St Margarets Chambers
For Charlotte Street Estates

Lightwell Elevations -
Proposed Repairs and
Conditions 1/2

scheme 1907
drwg no. **P(236)**
revision

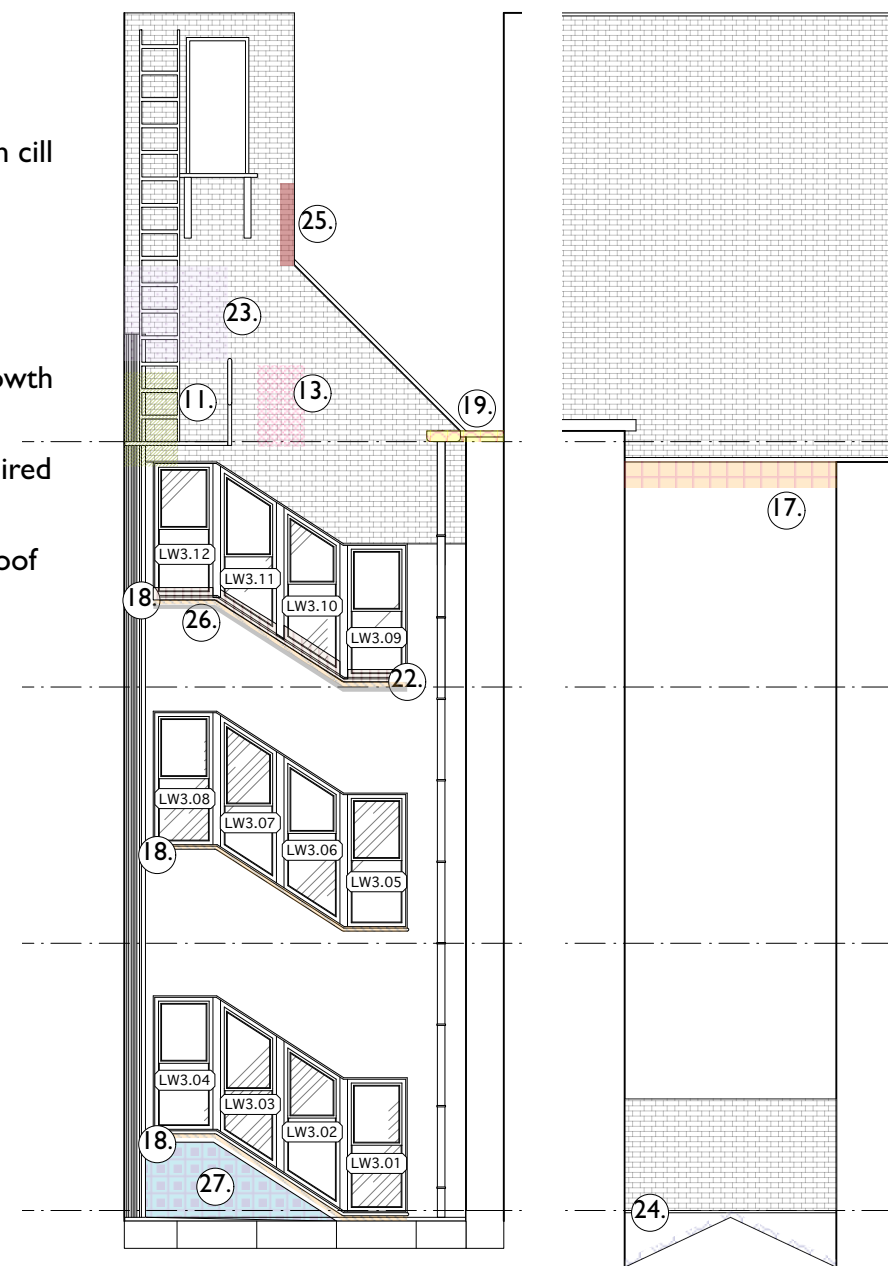
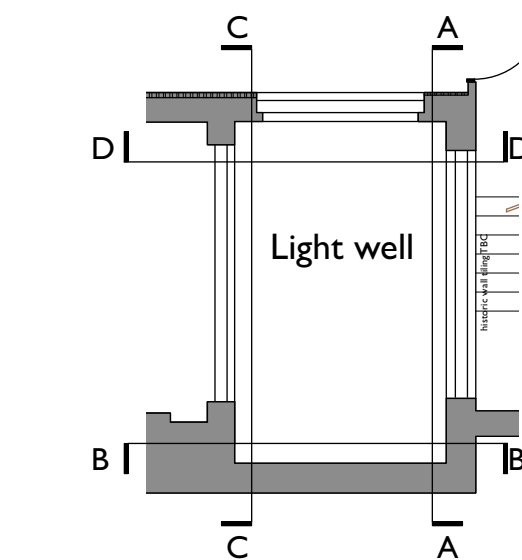
- 1 Sandstone erosion - close inspection required.
- 2 Holes left by redundant fixings - mortar fill in accordance with specification.
- 3 Gaps in brickwork. Close inspection required to inform replacement with matching material.

- 4 Missing pointing between frieze panels. Reinststate in accordance with specification.
- 5 Redundant plant equipment carefully remove and make good fabric in accordance with specification.

- 6 Eroded sandstone coping. Close inspection required. Replacement matching stone inserts may be required to prevent further deterioration.
- 7 Rusting lintels Clean off and repaint in accordance with specification.

- 8 Biological growth to be removed from roof level.
- 9 Coping water staining. May require repointing. Close inspection required.
- 10 Previous repairs to sandstone. Poorly matched aesthetic and presumed composition, but no evidence repairs are causing damage to surrounding historic fabric. Add to building maintenance plan for regular monitoring.

- 11 Biological growth to stone to be cleaned in accordance with specification.
- 12 Water staining may be caused by missing pointing. Close inspection required to inform repair strategy.

- 13 Signs of cracking. Further inspection required on site.
- 14 Redundant cables/lights/alarm box. Carefully remove
- 15 Residue from former sign to be cleaned off sandstone. Method pending site trials.

- 16 Existing timber to be carefully removed from brickwork

- 17 Clean off atmospheric dirt from glazed tiles
- 18 Redecorate cill
- 19 Clean-out gutters
- 20 Missing slate to be investigated once high level access provided
- 21 Repair and redecorate timber window frame and rotten cill
- 22 Clean concrete cill
- 23 Reinststate missing pointing
- 24 Inspect felt roof
- 25 Loose board and flashing to be repaired
- 26 inspect stone cill. Possible damage causing biological growth and staining to wall
- 27 Paint flanking and signs of damp further inspection required

Allow for the renewal of gutters and rainwater outlet to roof

Flashings to be renewed as required
